Access Compliance Report

Public Rights-of-Way

(Curb Ramps)

Intersection ID: 12858	Main Street: AMESBURY_AV	Cross Street: ENFIELD_RD	Location: NE
ADA ID: FF433E6E5E1C	Ramp Type: Para	Initial Pass/Fail: Fail	Overall Compliance: No
Severity Score: 13.75			
Codes/Mitigation Info/Possible Solution		Field Measurements/Component Compliance

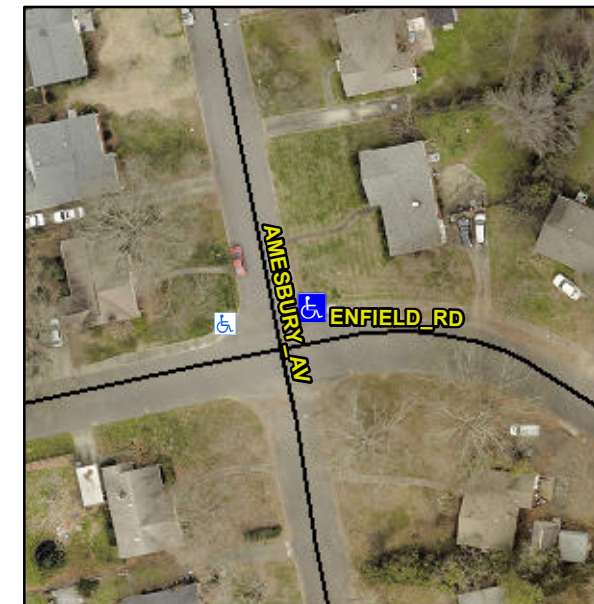
R304.5.3, R304.3.2

Compliance	Description	Data	Compliance	Description	Data
N/A	Ramp Length LT (in)	44.0	N/A	Ramp Length RT (in)	53.0
Yes	Ramp Width LT (in)	80.5	Yes	Ramp Width RT (in)	80.0
Yes	Ramp Slope LT (%)	5.9	No	Ramp Slope RT (%)	11.4
No	Ramp XSlope LT (%)	3.7	No	Ramp XSlope RT (%)	3.2
N/A	Landing Length (in)	N/A	N/A	DWS Provided?	N/A
N/A	Landing Width (in)	N/A	N/A	DWS Contrast?	N/A
N/A	Landing Slope (%)	N/A	N/A	DWS Length (in)	N/A
N/A	Landing X Slope (%)	N/A	N/A	DWS Full Width?	N/A
N/A	Landing Curb? (Y/N)	N/A	N/A	DWS Offset (in)	N/A
N/A	Shared Landing?	N/A			
N/A	Gutter Ponding?	N/A	N/A	Gutter Slope (%)	N/A
N/A	Gutter Lip Ht (in)	N/A	N/A	Gutter X Slope (%)	N/A
N/A	Painted X Walk1?	No	N/A	Painted X Walk2?	N/A
	X Walk 1 Direction	To W		X Walk 2 Direction	N/A
N/A	X Walk 1 Width (in)	N/A	N/A	X Walk 2 Width (in)	N/A
	X Walk 1 Slope (%)	0.0		X Walk 2 Slope (%)	N/A
	X Walk 1 X Slope (%)	3.5		X Walk 2 X Slope (%)	N/A
N/A	Ramp inside XWalk1?	N/A	N/A	Ramp inside XWalk2?	N/A

Remove & Replace Entire Ramp.
